E5071C-08

S E R V I C E N O T E

E5071C - ENA Series Network Analyzer, 9 kHz to 20 GHz

The measurement data is unstable due to a Receiver Port degradation, though a user performs calibration.

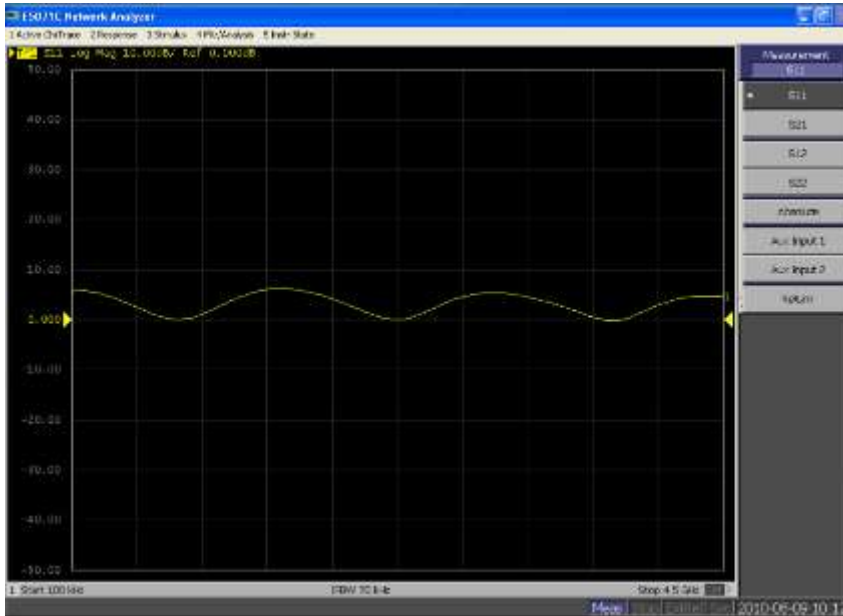
(2) Port-1 S11, Port-2 S22, Port-3 S33 or Port-4 S44 has trace distortion as shown as in below picture due to Mixer-IC infant transistor failure, though there is no cable or adapter connected to the port.

When the above symptom can be identified without connecting a cable or adapter to a port, then run the attached Mixer-IC diagnostic Test ***before performing Adjustment*** and if a Port results in FAIL, then replace the receiver board with the FAIL result.
